SERVICE BULLETIN

B-053

VOLTAGE REGULATOR INFORMATION UPDATE

To communicate a need for dealers to make corrections to the Service Manuals of models with series style voltage regulator/rectifier.

Test 7.6 (Part 1 of 2)

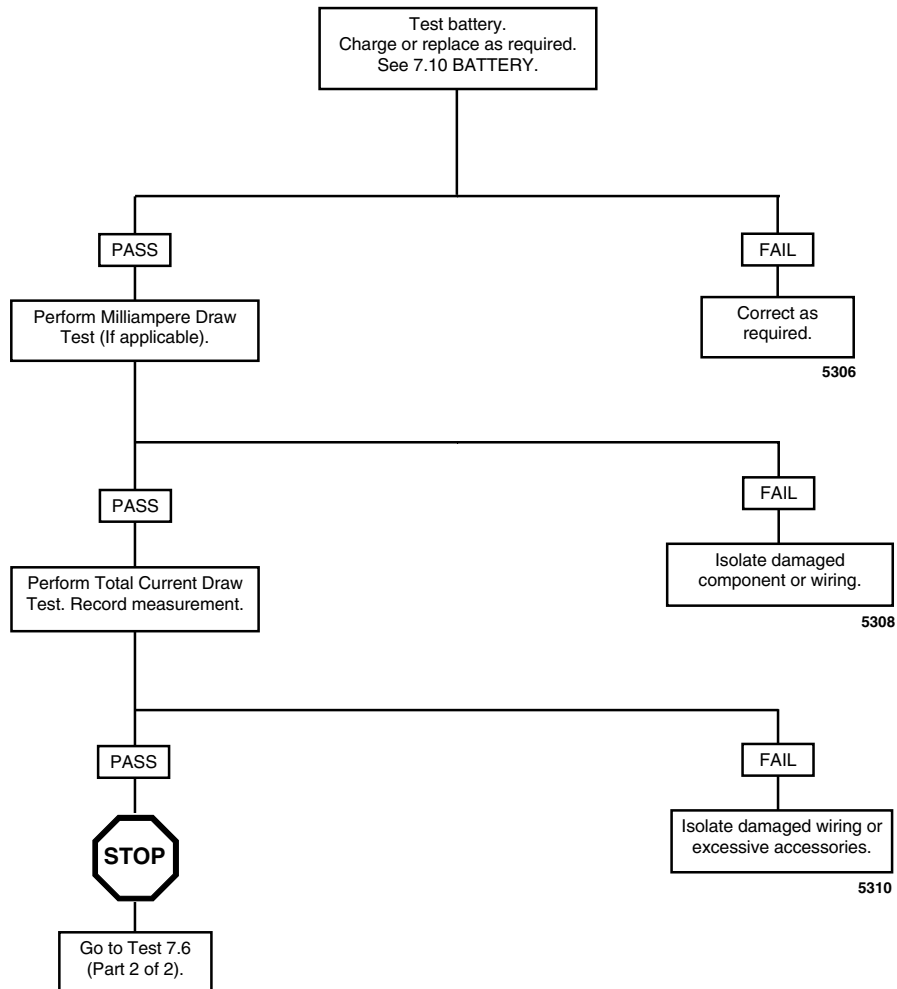
- In Section 7.6 under General, the voltage regulator is referred to as "a series regulator with shunt control." Remove the phrase "with shunt control."
- In Section 7.6, replace page containing Test 7.6 (Part 1 of 2) of both manuals with a copy of page 2 of this bulletin.
- In Section 7.6 under Testing, remove the Regulator Bleed Test from the manuals.
- In Section 7.6 under Milliampere Draw Test, maximum reading in both manuals should be 2.0 milliamperes.
